Entergy Nuclear Generation Co.
Pilgrim Nuclear Power Station
600 Rocky Hill Road
Plymouth, MA 02360

February 2, 2001
ENG C Ltr. 2.01.015

**MODIFICATION OF TECHNICAL SPECIFICATION CHANGE SUBMITTAL
CONCERNING PRESSURE-TEMPERATURE LIMIT CURVES**

PILGRIM REACTOR VESSEL PRESSURE-TEMPERATURE LIMITS
HYDROSTATIC AND LEAK TESTS

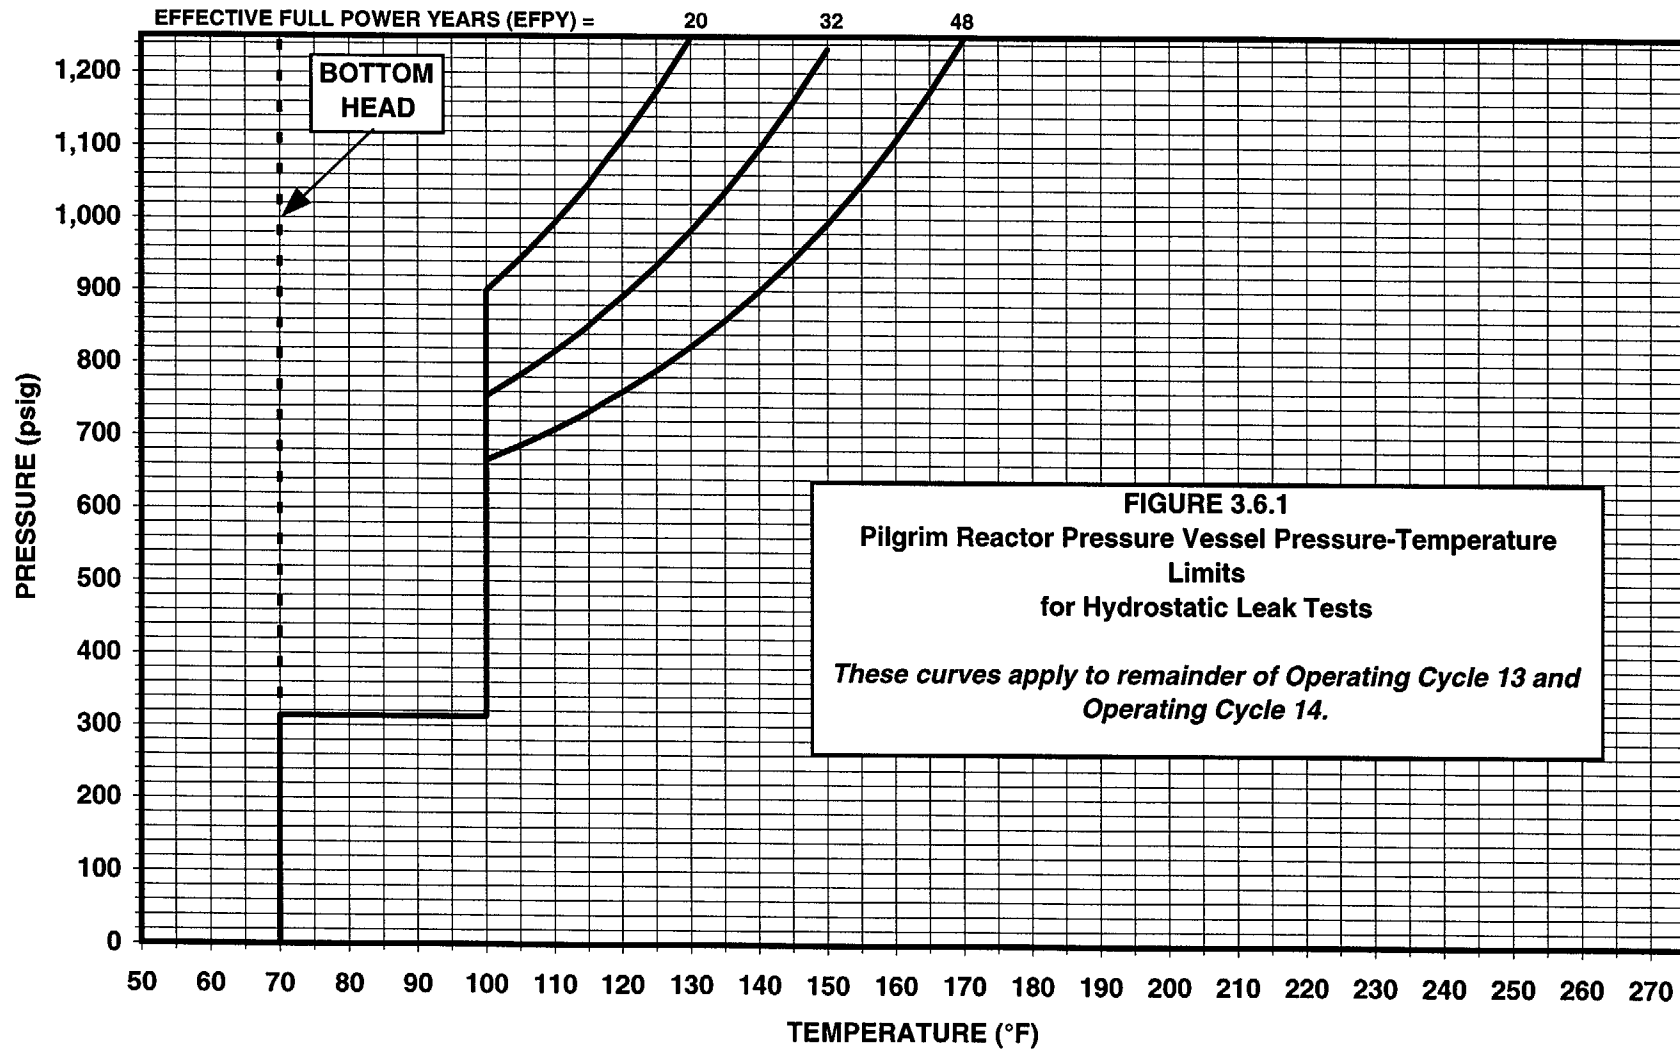
This proposed change to Pilgrim's November 22, 2000, amendment request adds a footnote to Figures 3.6.1, 3.6.2, and 3.6.3 of Pilgrim's Technical Specifications that states:

These curves apply to remainder of Operating Cycle 13 and Operating Cycle 14.

During NRC review of the amendment request, Pilgrim learned that a new methodology for calculating neutron fluence was soon to be approved by the NRC for industry use. The November 22, 2000, amendment request curves used an approved fluence methodology that may be superseded by the new methodology. Pilgrim, therefore, is amending the November 22, 2000, amendment request by limiting application of the proposed curves to essentially one cycle, that is, the remainder of operating cycle 13 and operating cycle 14. Operating cycle 13 is nearly over; operating cycle 14 is scheduled to commence at the conclusion of refueling outage 13, currently scheduled for May, 2001.
